1. Viewpack

4 HOWARD CT- HARDSCAPE.PDF
13 WARREN ST- REV 01-0557 ROTATE SHED PERGOLA.PDF
13 WARREN ST- REV 01-0558-GATE - FENCE.PDF
12 LINCOLN AVE - CABANA REVISIONS.PDF
12 LINCOLN AVE - GARAGE REVISIONS.PDF
25 UNION - HANDICAP RAMP.PDF
25 FEDERAL STREET - HVAC MINISPLIT.PDF
30 CLIFF RD- HOUSE LIFT AND FOUNDATION.PDF

Application to the HISTORIC DISTRICT COMMISSION, Nantucket, Massachusetts, for a

CERTIFICATE OF APPROPRIATENESS

H.D.C. SITE PLAN
SCALE: 1/8"=1'-0"

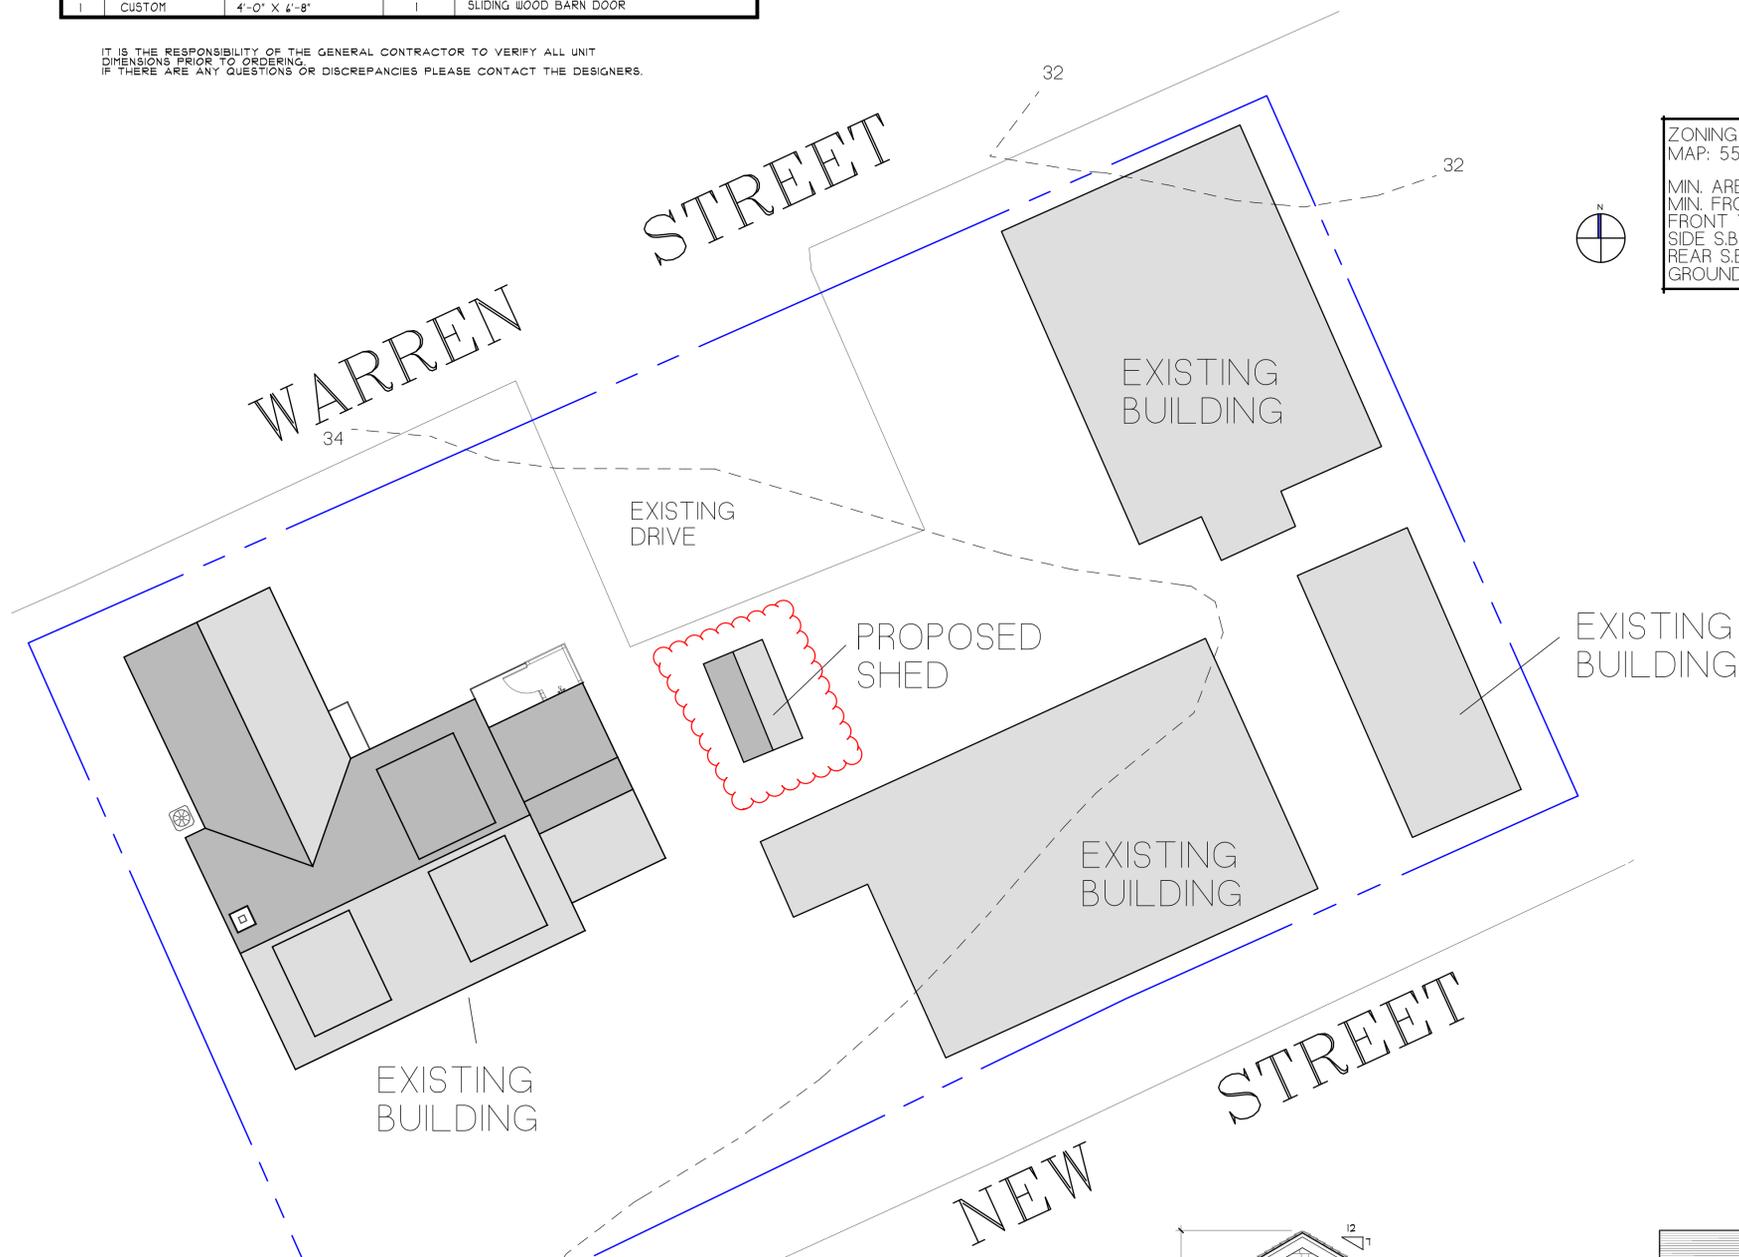
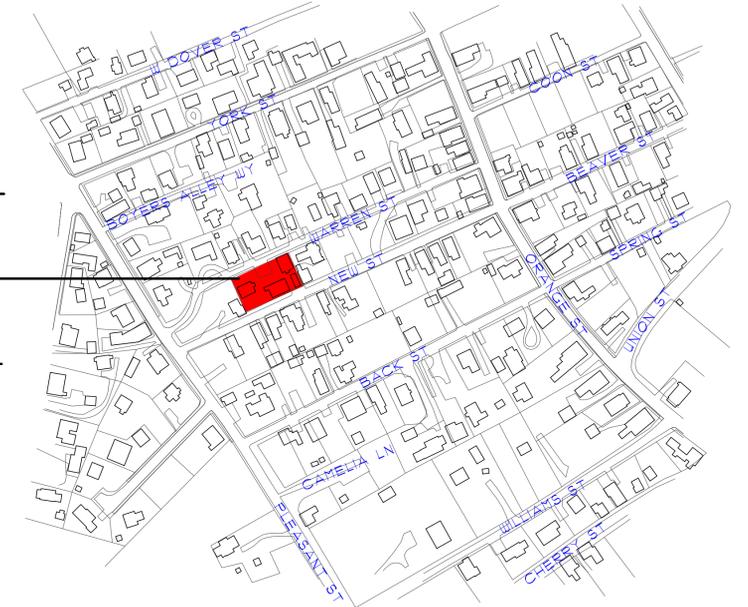
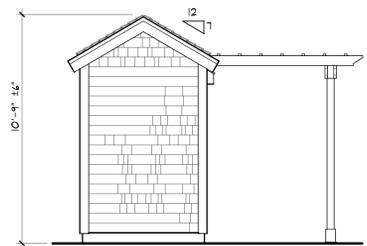
ROTATE APPROVED SHED 90°
ADD PERGOLA

1 Floor Plan

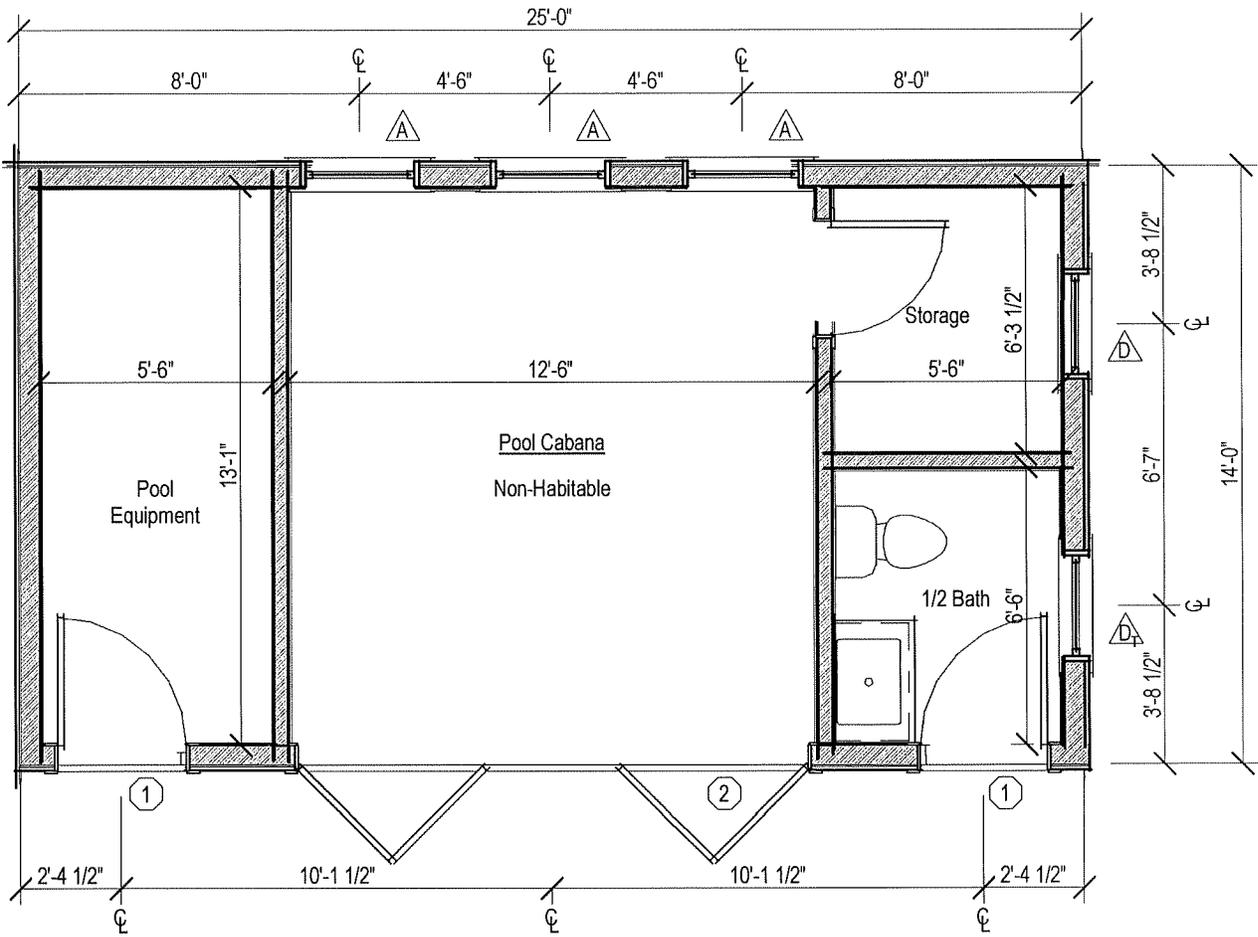
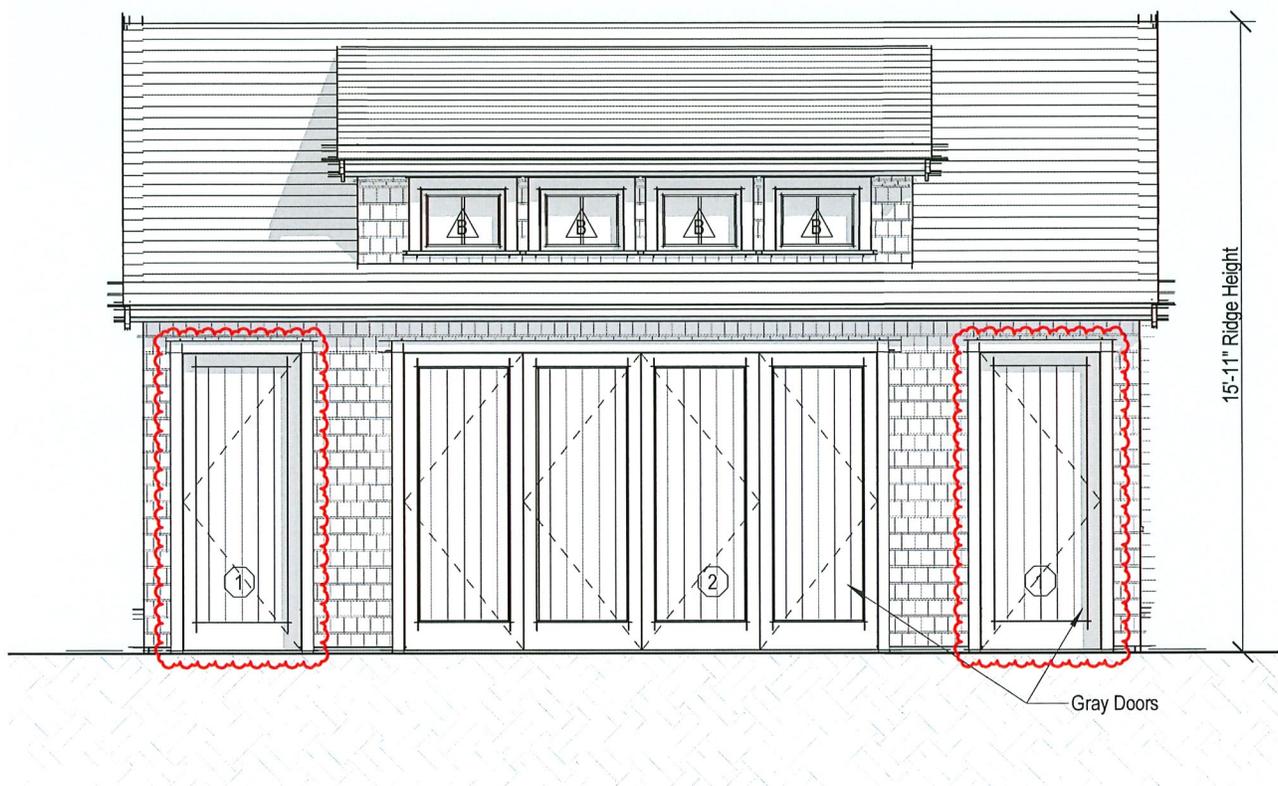
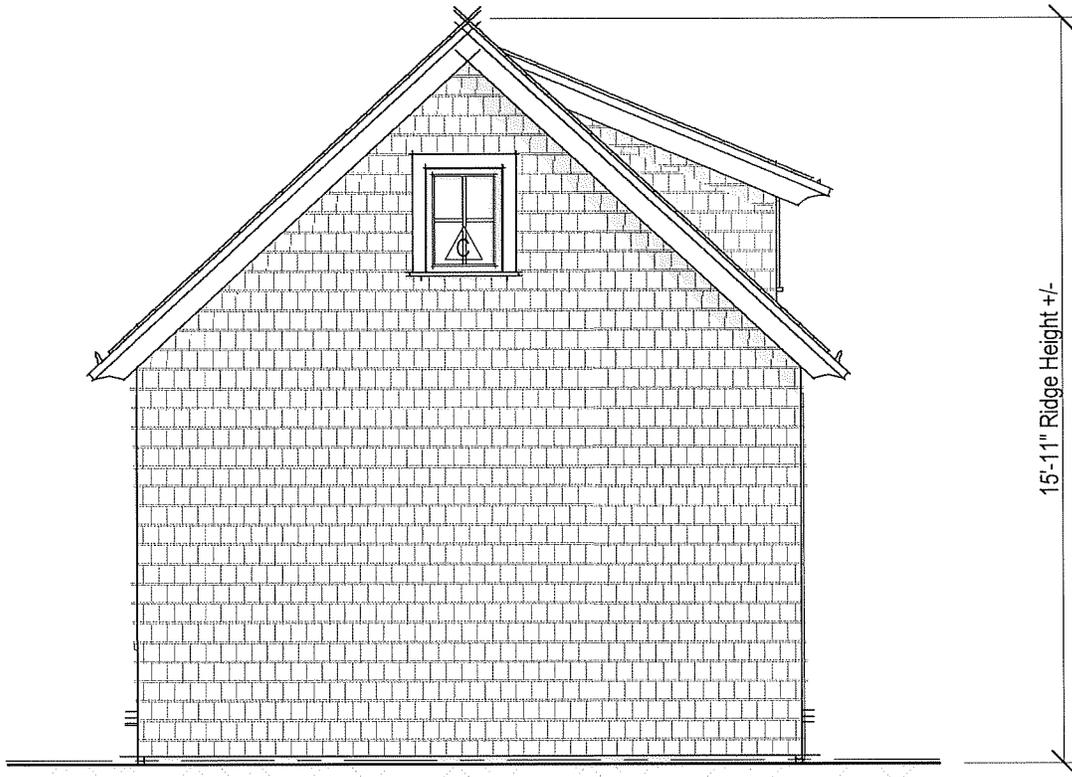
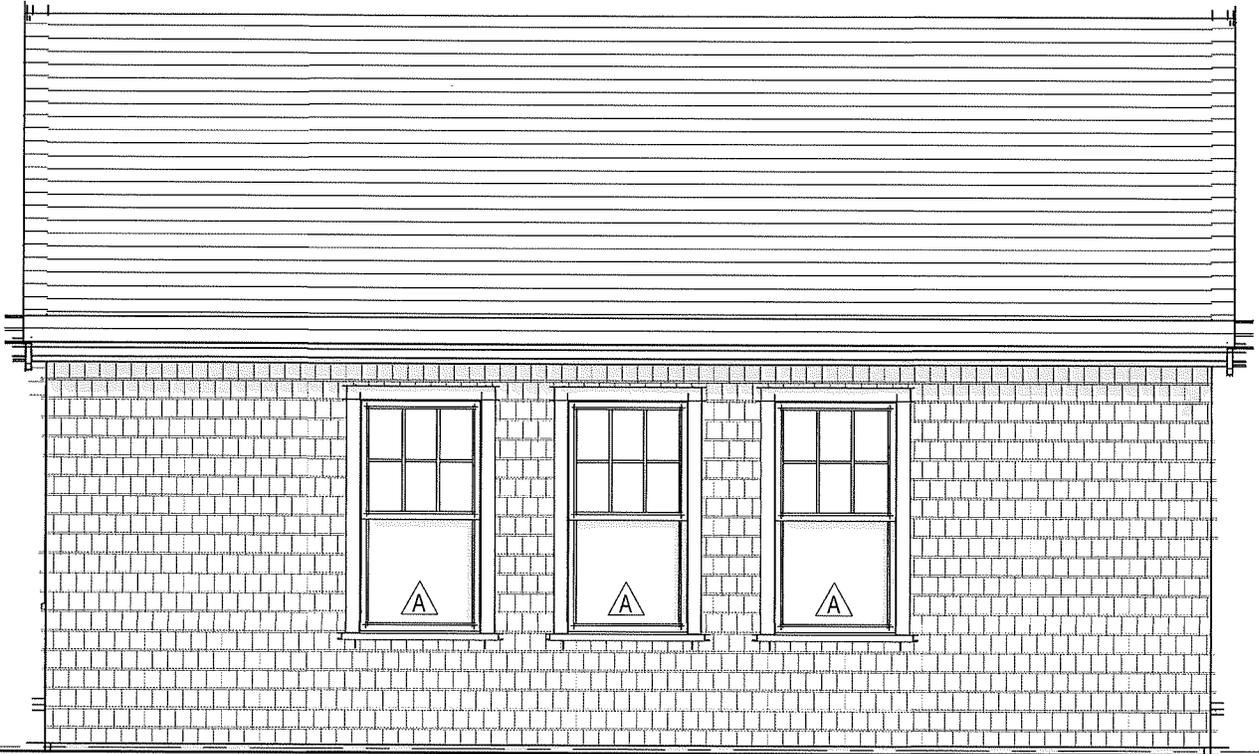
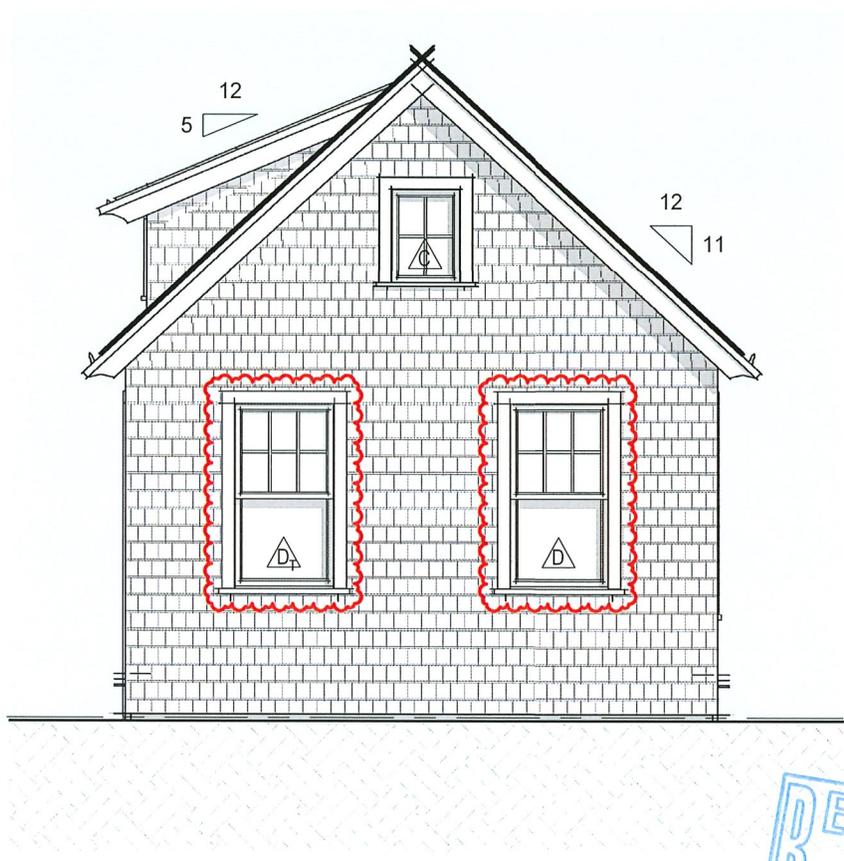
Historic Name: N/A
 Original Date: _____ (describe)
 Original Builder: _____
 Is there an HDC survey form for this building attached? Yes N/A
 REVISIONS* 1. East Elevation Door style revisions & revise roof trim details
 2. South Elevation
 3. West Elevation
 4. North Elevation Add two windows
 *Cloud on drawings and submit photographs of existing elevations.
